From: Stephen O'Kane [stephen.okane@AES.com]
Sent: Tuesday, October 23, 2012 6:07 PM
To: Chris Perri
Cc: Robert.Mason@CH2M.com; 'Jerry.Salamy@CH2M.com'; McKinsey, John A.; Foster, Melissa A.; Miller, Felicia@Energy
Subject: RE: HBEP emission rates and modeling results
Attachments: Attachement_1.pdf; SCAQMD response letter 10-23-2012.pdf; Attachement_2.pdf; Turbine Data

RE: Huntington Beach Energy Project Permit Application (Facility ID# 115389)

AES Huntington Beach, LLC (AES-HB) is submitting this letter in response to the October 5, 2012 South Coast Air Quality Management District's (AQMD) electronic mail request for additional information needed to complete the Huntington Beach Energy Project (HBEP) engineering evaluation. Listed below are your specific requests followed by AES-HB's response.

ATTACHMENT 1
AES HBEP Start Up Curve
 AES Huntington Beach Energy Project
 Huntington Beach, California

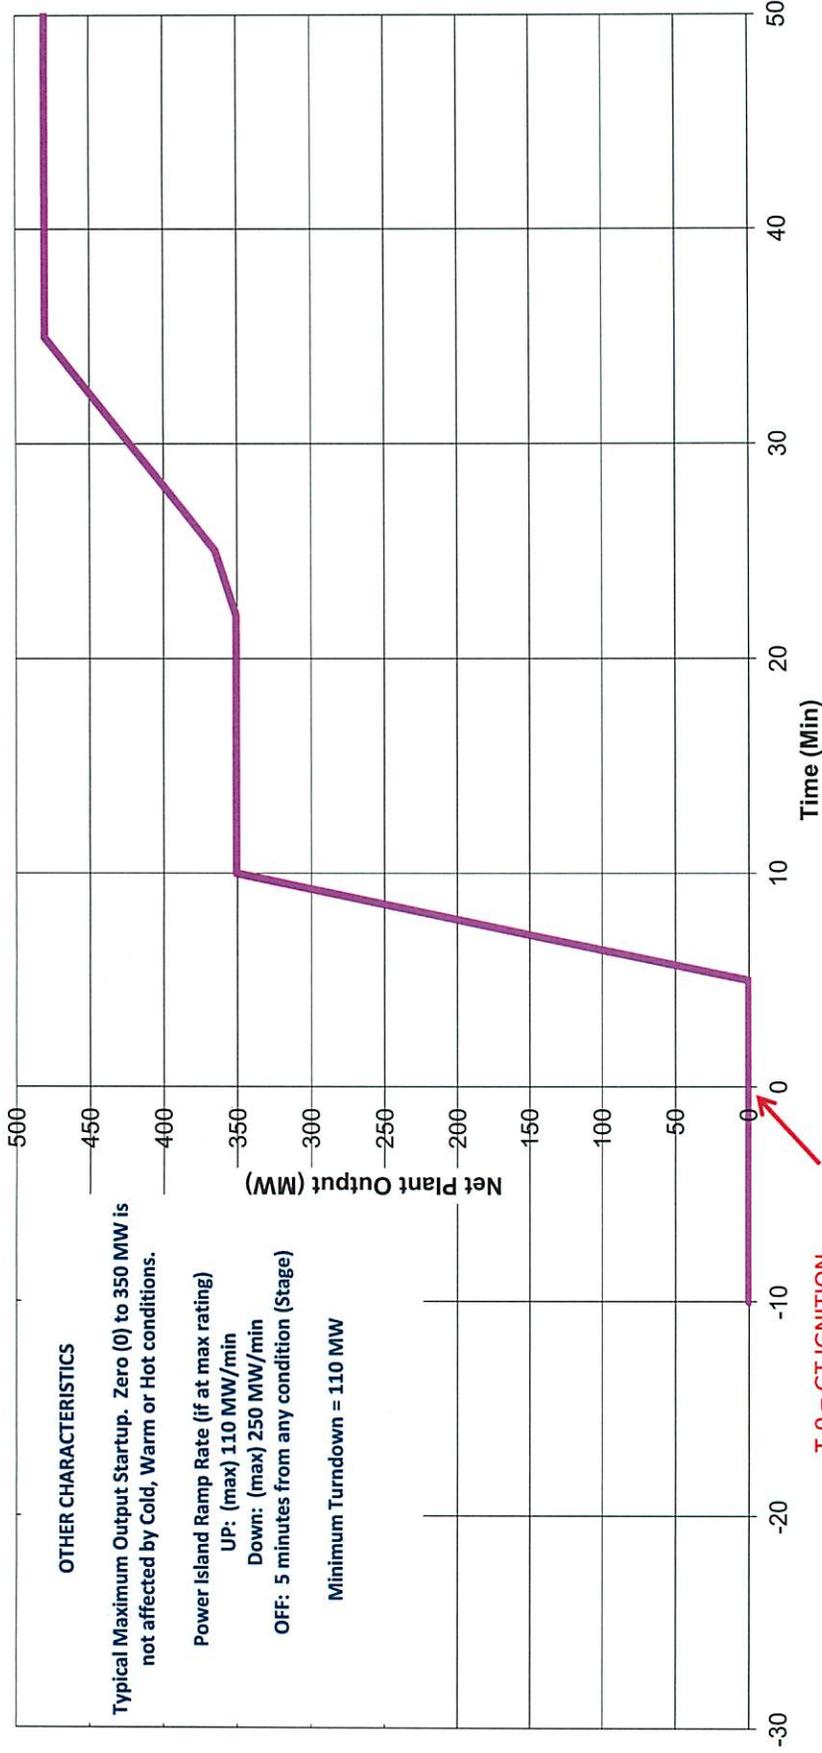
SCAQMD-DR3: The 1 hour NOx should be done using stack parameters that correspond to a cold start up, unless you can justify that case 15 simulates a cold start up.

Response: The overall duration of a cold, warm, or hot start (i.e., time required to achieve BACT levels) is dependent on the SCR and oxidation catalyst systems reaching minimum operating temperatures as well as the conditions of the steam cycle. However, because of the HBEP turbine's rapid start technology, the duration required from initiation of fuel to the turbine reaching 100 percent load is only 10 minutes for all three startup scenarios (hot, warm, and cold). Attachment 1 presents a startup curve for the turbine.

Therefore, the Applicant expects that the turbines will be able to operate at a minimum of 70 percent operating load rate from 10 minutes through the time when the emission control systems are fully functional during all starts (i.e., the remaining 50 minutes of the hour). Because the 1-hour NO₂ modeling presented in the permit application assumed the maximum hourly cold start up emission rate for NOx of 25.5 lb/hr for turbine exhaust conditions at 70, 80,

90, and 100 percent load with and without duct burners at 32°F, 65.8°F, and 110°F ambient temperature (which includes Case 15), the results presented in the AFC Table 5.1-29 would represent the highest 1-hour NO₂ impacts modeled for all load and temperature conditions, including a cold start.
